PERMIT

SEWAGE DISPOSAL SYSTEM

Leonard E. Sutton Company IS PERMITTED TO INSTALL ALTER

SUBDIVISION Ken Warfield ROAD 4260 Ten Oaks Road LOT 6

PERMIT CARD

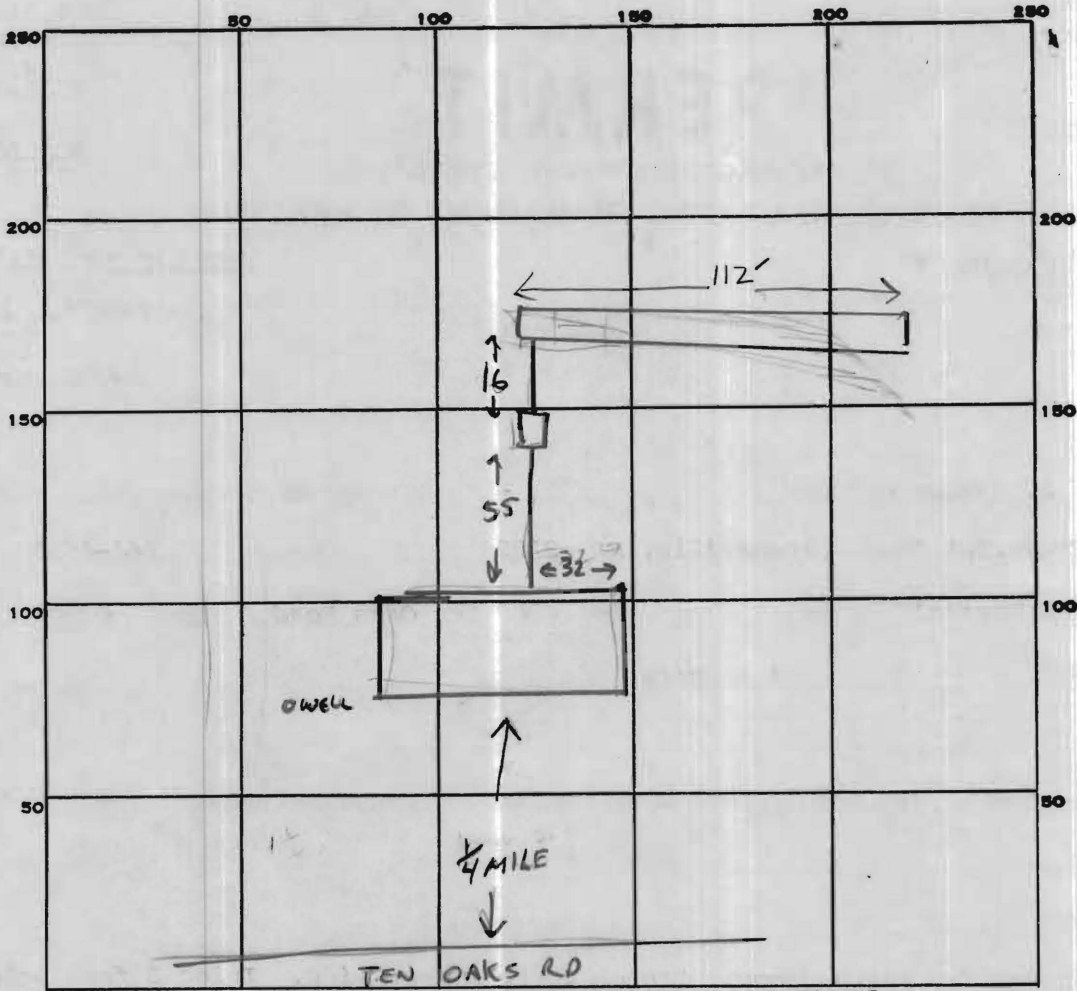
TILE FIELD, DEPTH 9 FT. TRENCH WIDTH 2+ (CAVED TO 4' IN SOME SPOTS) FT.

GRAVEL DEPTH 6 FT IN. TOTAL LENGTH 112' FT.

NUMBER OF TRENCHES 1 TOTAL BOTTOM AREA 672 ^{ONE SIDEWALL}

REMARKS 6-27-85 OK TO ADD GRAVEL AS TRENCH IS DUG TO PREVENT CAVING. (CW)

OK TO COVER ALL WORK

DATE SYSTEM APPROVED 6-27-85
